Addendum No. 03

SUBJECT: Willamette River: Stormwater Source Control Improvements Project
Lower Columbia River, Northeast Portland, Stadium Freeway
Multnomah
Grading, Drainage, Paving, Signing, Illumination, and Roadside Development
(Bids Closing April 30, 2026)

1. Plan sheets BA03, BA04, BA08, C201, C581, ES01, FA201, FB201, GA201, HA201, HA401A, HB202, PA201, S02, TA201 are replaced with revised plan sheets BA03, BA04, BA08, C201, C581, ES01, FA201, FB201, GA201, HA201, HA401A, HB202, PA201, S02, TA201.

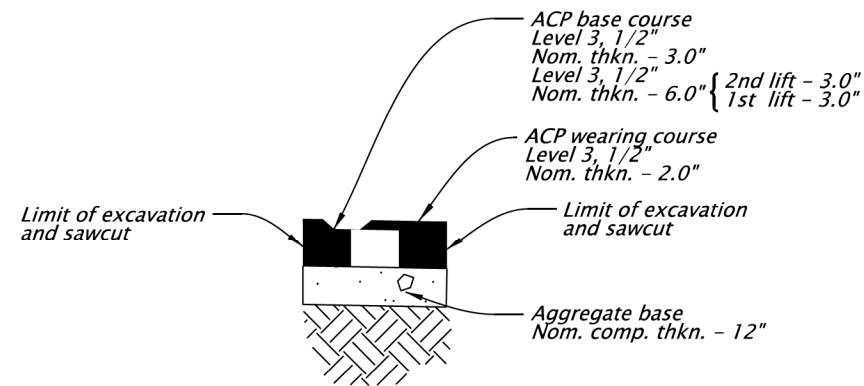
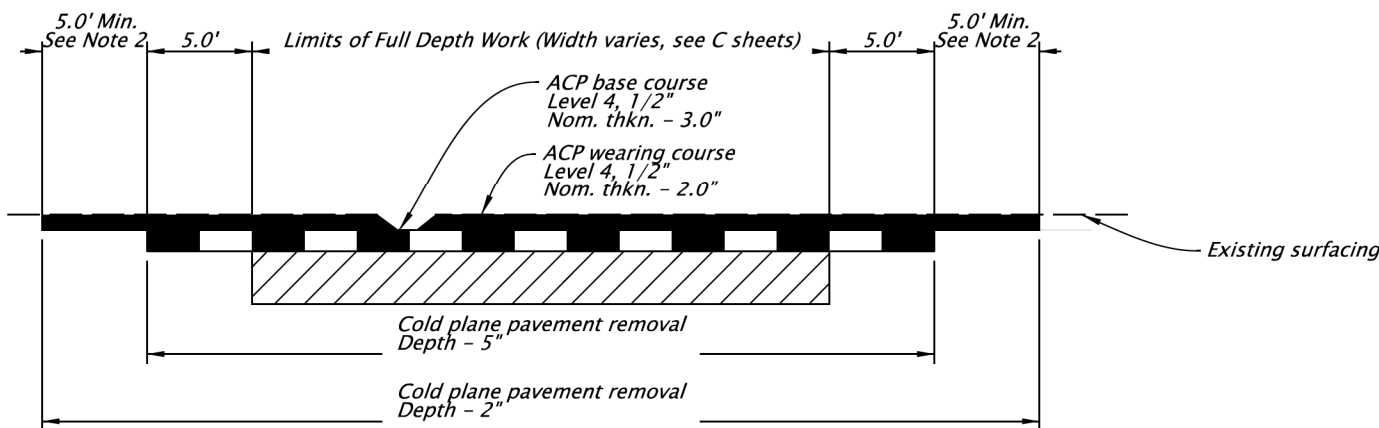
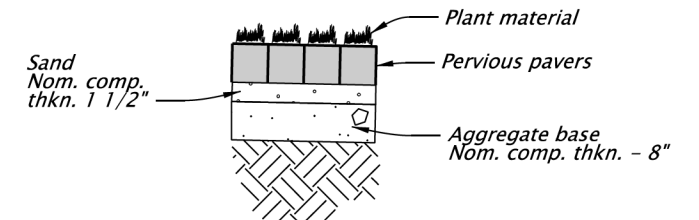
No.	DATE	REVISIONS	BY
1	04-17-26	Removed note 8	A.P.J.

DETAILS
SHEET NO. BA04

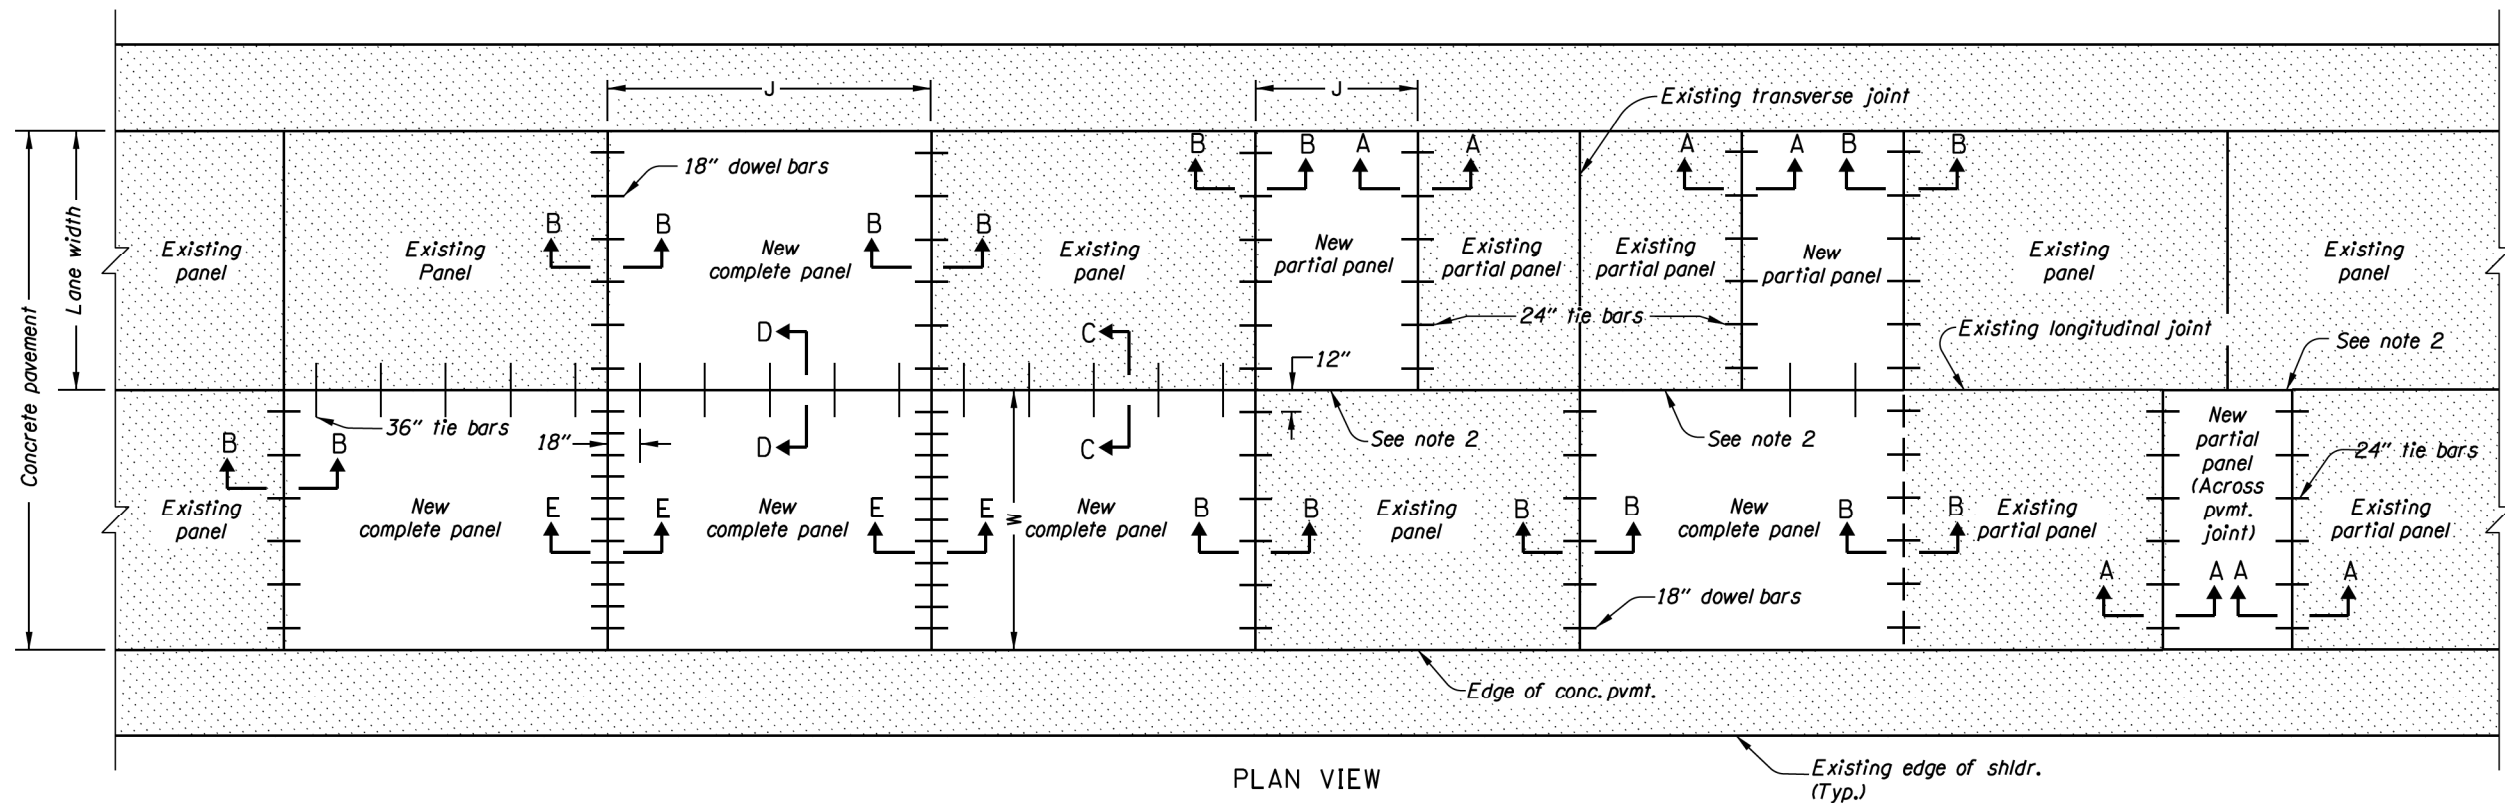
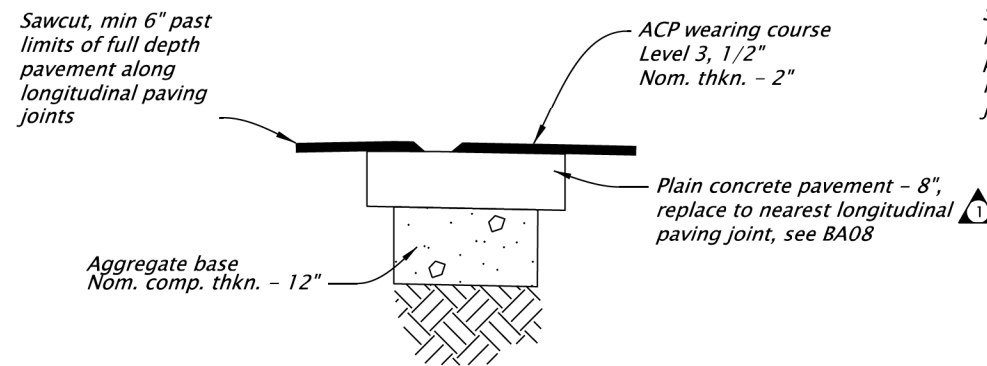
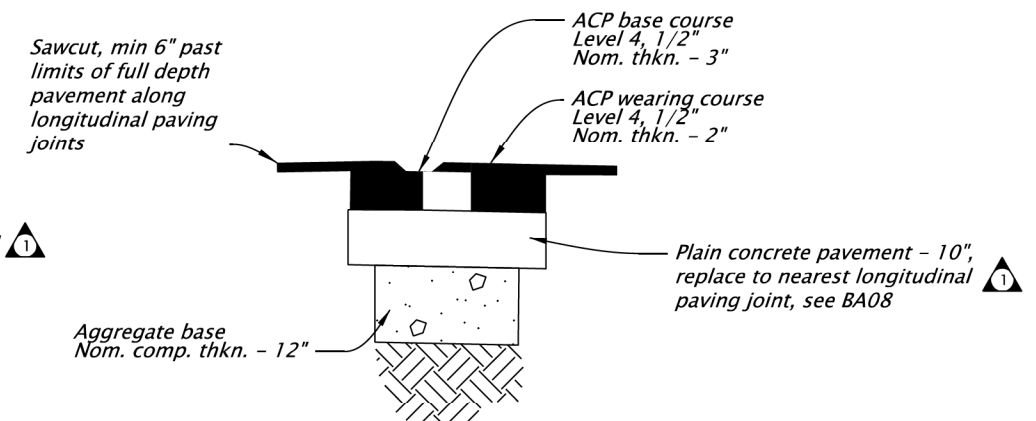
No.	DATE	REVISIONS	BY
1	04-14-26	Removed 'undowelled' from detail notes (2)	A.P.J.
2	04-17-26	Removed "(J)" from repair length column	A.P.J.

DETAILS

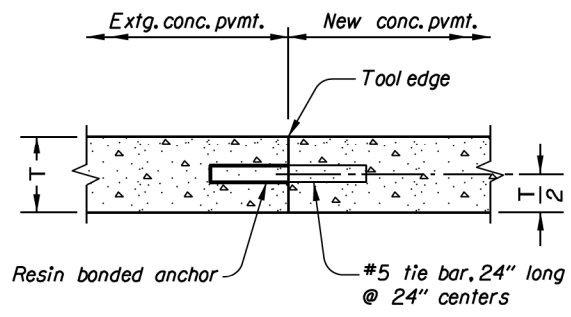
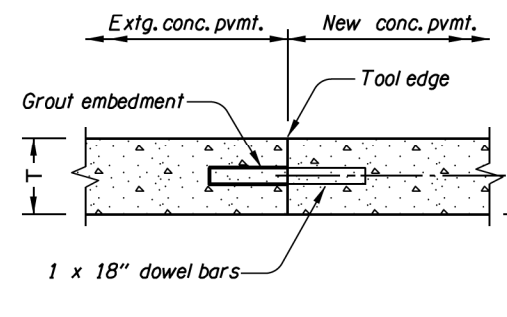
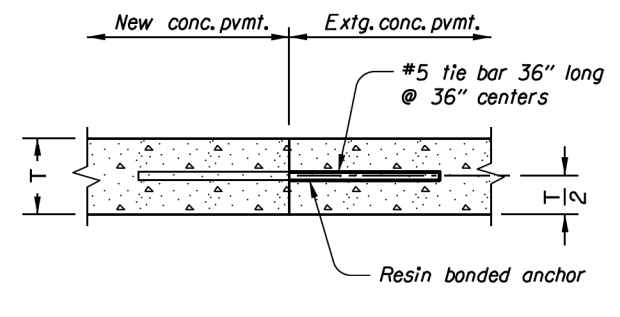
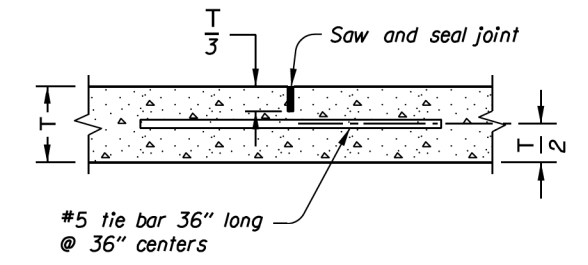
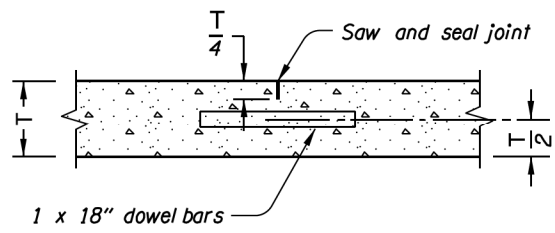
No.	DATE	REVISIONS	BY
1	04-20-26	Added general note 8	A.P.J.

8. Install contraction joints (Sections B-B and E-E) between panels with a spacing interval no less than 12' and no greater than 15'.
